APPLICATION NO.	FILING DATE	FIRST NAMED INVENTOR	ATTORNEY DOCKET NO.	CONFIRMATION NO.
09/788,420	02/21/2001	Oh Nam Kwon	8733.388.00	5851
30827	7590	06/16/2004	EXAMINER	
MCKENNA LONG & ALDRIDGE LLP 1900 K STREET, NW WASHINGTON, DC 20006			WANG, GEORGE Y	
			ART UNIT	PAPER NUMBER
			2871	
DATE MAILED: 06/16/2004

<b>Office Action Summary</b>	<b>Application N .</b> 09/788,420	<b>Applicant(s)</b> KWON ET AL.	
	<b>Examin r</b> George Y. Wang	<b>Art Unit</b> 2871

## DETAILED ACTION

FIG. 8

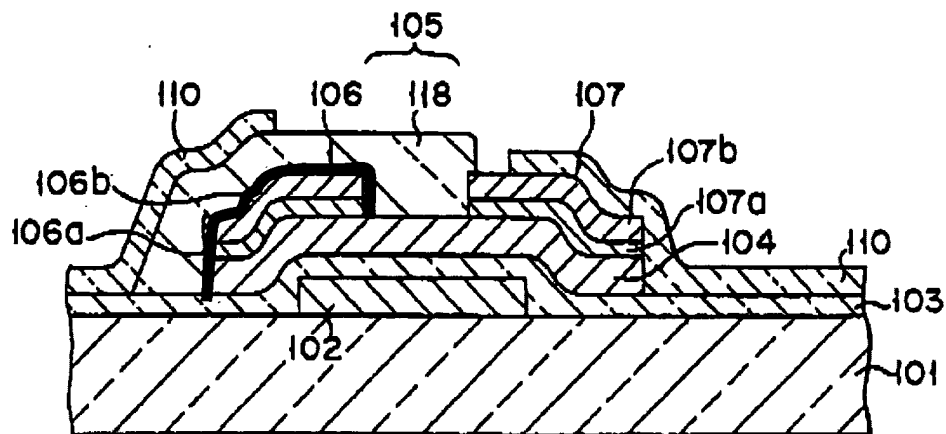
Applicant's first argument is that the second insulating layer of the Wakai reference does not teach "a contact hole exposing a portion of the third conductive layer." However, Examiner asserts that the Wakai reference clearly teaches this in Fig.

8. See bolded area below.

FIG. 8

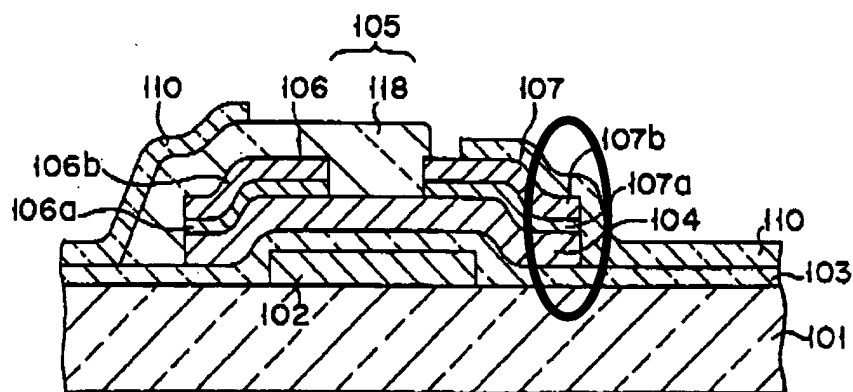
Applicant's second argument is that the Wakai reference does not disclose a fourth conductive layer on the second insulating layer and electrically contacting the third conductive layer. Examiner asserts that the Wakai reference does teach this in Fig. 8. See circled area below.

Accordingly, Applicant's arguments are not persuasive. The Wakai reference clearly teaches all the claimed limitations. Therefore, Examiner, holds to the validity of the Wakai reference and maintains rejection.
